REPORT TO COUNCIL

Application: DP16-0069 Owner: Coastal Hollypark Properties

Address: 1580 Hwy 33 West Applicant: GTA Architecture Ltd

Subject: Form and Character Development Permit

4.0 Proposal

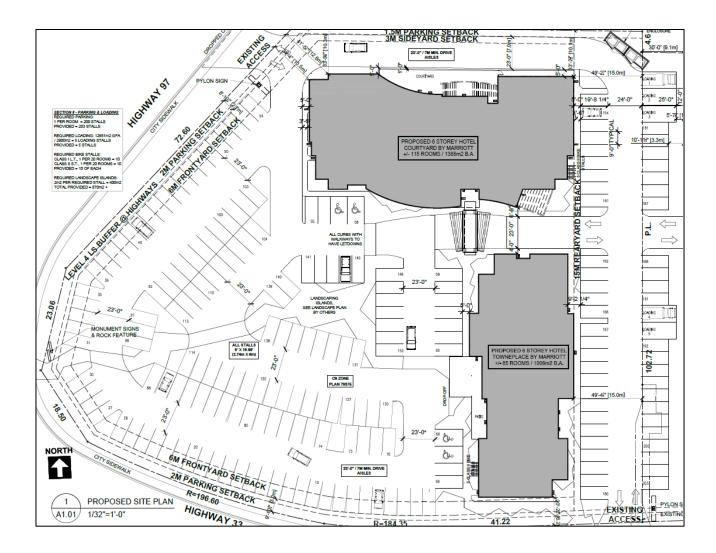
The proposed hotel buildings themselves are adequate structures, with some visual interest created by varying shades of stucco and rooflines. The site layout, with the 203 stall parking lot opening directly onto the highway, would continue to repeat the auto-centric layouts that have characterized Kelowna's highway corridor for so long.

The applicant has attempted to allay the site layout concerns through landscaping provisions, with 100 deciduous trees proposed to act as screening and break up the visual impact of the parking lot. No information has been given about quantity and quality of soil to give any assurance of the survivability of the proposed landscaping in the parking areas.

City staff have been discussing the project with the applicant since late 2014. At every discussion, staff have recommended that the applicant consider alternative configurations avoiding large expanses of exposed parking along the Highway 33 and 97 frontages. The applicant has indicated that the national hotel chain is unwilling to consider the highway fronting configuration, forcing the applicants hand in applying for the proposed layout.

The proposed site is at one of the busiest intersections in the City, which is expected to only get busier. Such a prominent location needs to be developed with as high a quality of development as is feasible, hewing to City design guidelines. If the hotel chain is unwilling to consider an alternative configuration, the proposed parcel may not be suitable for their intended use. It is the opinion of Community Planning staff that the parking forward design proposed by the applicant does not achieve these goals, and is not suitable for such a prominent location.

- 6. That a covenant be registered on the neighbouring property dedicating parking on the property to the new hotel development.
- 7. That 50% of parking surfaces be paved with unit pavers to promote ground water infiltration and further reduce the aesthetic impact of asphalt.
